Subject: **WATER AND WASTEWATER CAPACITY AVAILABILITY LETTER**
333 Victoria Park – DRC Case No. R18071
323 NE 7th Avenue, Fort Lauderdale, Florida 33301

City of Fort Lauderdale
Public Works Department
Water and Wastewater Capacity Analysis

333 Victoria Park – DRC Case No. R18071
323 NE 7th Avenue, Fort Lauderdale, Florida 33301

Figure 2 – City Sewer Atlas

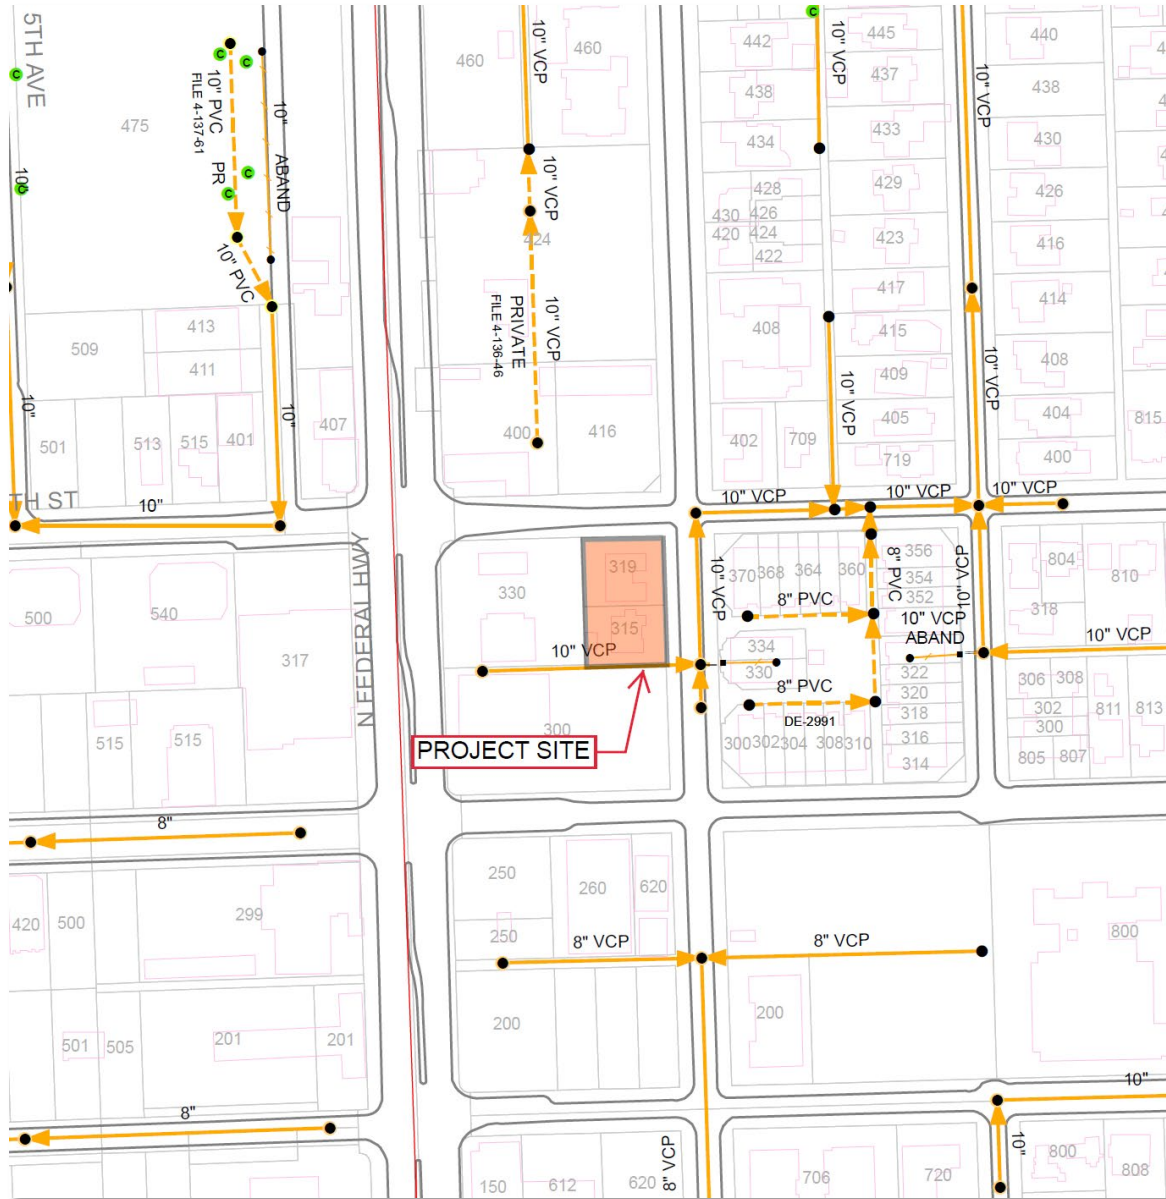
Wastewater: The site is currently served by a 10-inch gravity sewer main to the south of the project site. See Figure 2.

Due to the material and the age of the existing gravity sewer main, it can be reasonably estimated that the pipe is in poor condition. We recommend replacement of approximately 253 linear feet of gravity sewer main along the south of the project with a polyvinyl chloride (PVC) pipe.

Recommended Wastewater Infrastructure Improvements: We recommend replacement of approximately 253 linear feet of gravity sewer main spanning between the two existing manholes to the south of the property with a polyvinyl chloride (PVC) pipe.

Figure 3

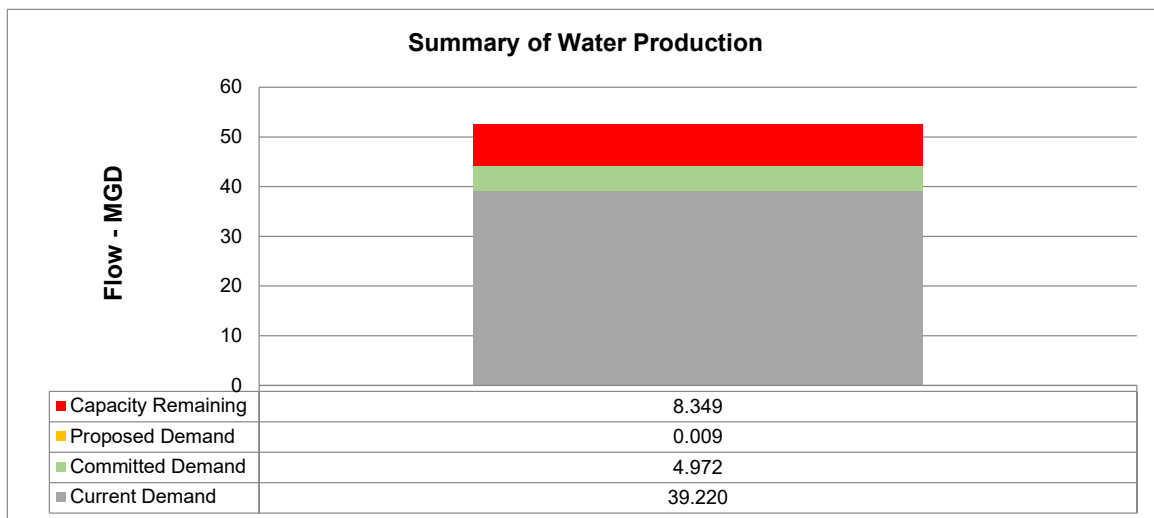
Evaluation of impact of Permitted Water Plant Capacity: The Fiveash and the Peele Dixie Water Treatment Plants are designed to treat 70 MGD and 12 MGD of raw water respectively (82 MGD total). The total permitted Biscayne aquifer water withdrawals for these plants is limited to 52.55 MGD per the South Florida Water Management District (SFWMD) permit number 06-00123-W.

The current twelve-month rolling average production at the two plants is 39.22 MGD. The previously committed demand from development projects in the permitting or the construction stage is 4.972 MGD. Combining these figures with the demand from the proposed project of 0.009 MGD, the required production would be 44.20 MGD. This is less than the allowable withdrawal limit of 52.55 MGD. Therefore, the water plants have sufficient capacity to serve this project. See Figure 3 below.

Recommended Water Infrastructure Improvements: No improvements required. Development shall utilize new 6-inch HDPE water main for water services.

Figure 4

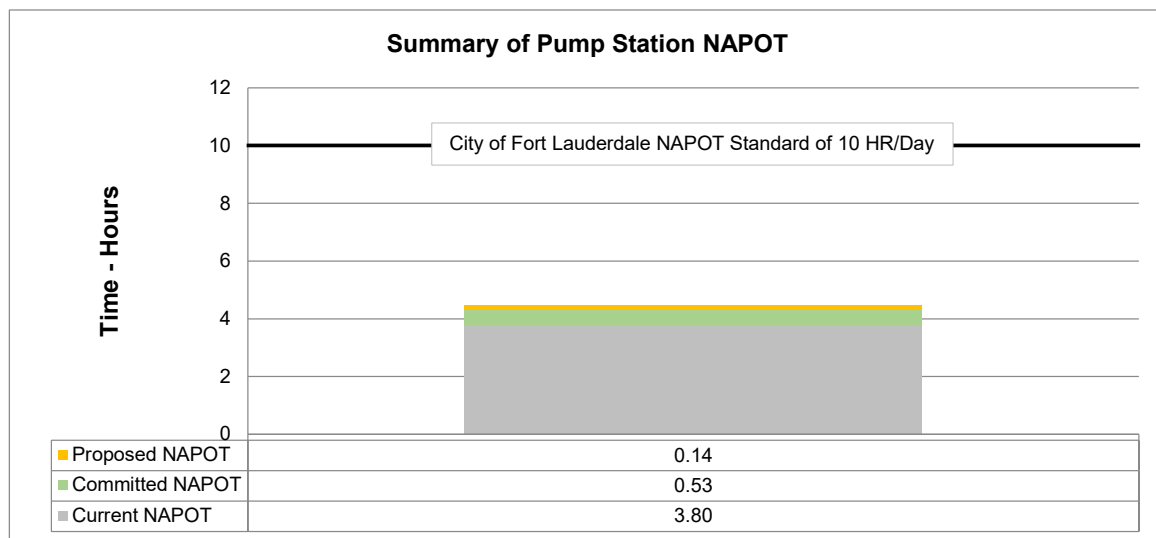
Evaluation of impact on pumping station: PS A-17 has a duty point of 843 gallons per minute (GPM) and has a Nominal Average Pumping Operating Time (NAPOT) of approximately 3.80 hours per day. Based on projected sewage flows, the pumping run times would increase approximately 9 minutes per day. Additionally, there are other committed flows from proposed developments within the PS A-17 basin resulting in 32 minutes of additional runtime. PS A-17 will have a NAPOT of 4.5 hours once the proposed developments are complete, less than the recommended average of 10 hours per day (see Figure 4 below).

Figure 5

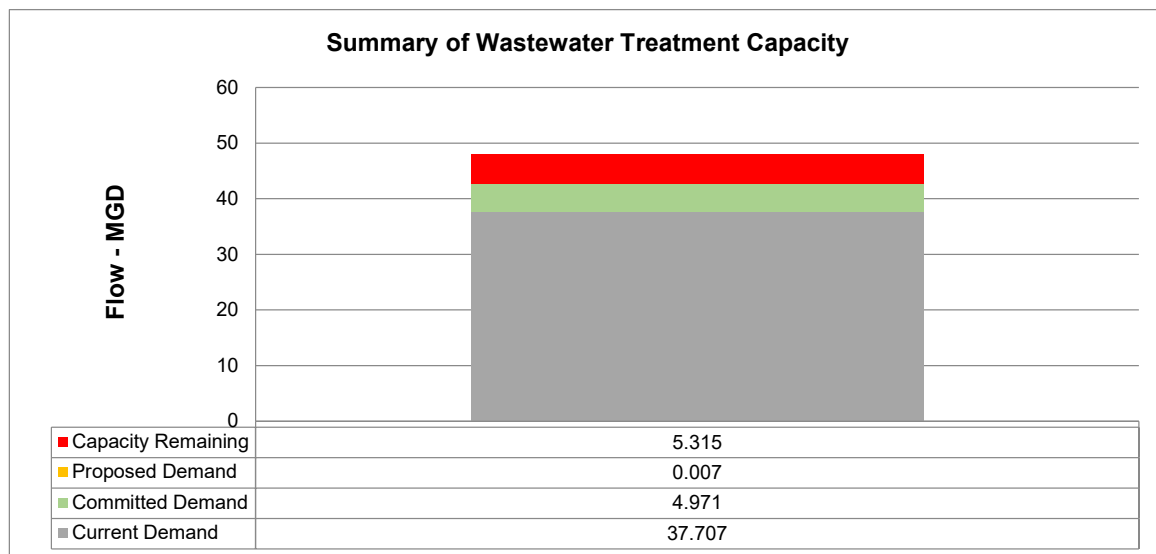
Evaluation of impact of Permitted Wastewater Plant Capacity: The City of Fort Lauderdale owns and operates the George T. Lohmeyer Regional Wastewater Treatment Plant (GTL), which provides wastewater treatment for the City of Fort Lauderdale. The Broward County's Environmental Protection and Growth Management Department's (EPGMD) Environmental Licensing & Building Permitting Division's licensed capacity for GTL is 48 MGD-AADF (Million Gallons per Day – Annual Average Daily Flow). The annual average daily flow (AADF) to the plant is 37.707 MGD. Combining the committed flows for previously approved projects of 4.971 MGD plus the 0.007 MGD net contribution from the project results in a total projected flow of 42.69 MGD. This is less than the permitted treatment plant capacity of 48 MGD. Therefore, the treatment plant has sufficient capacity to serve this project. See Figure 5 below.
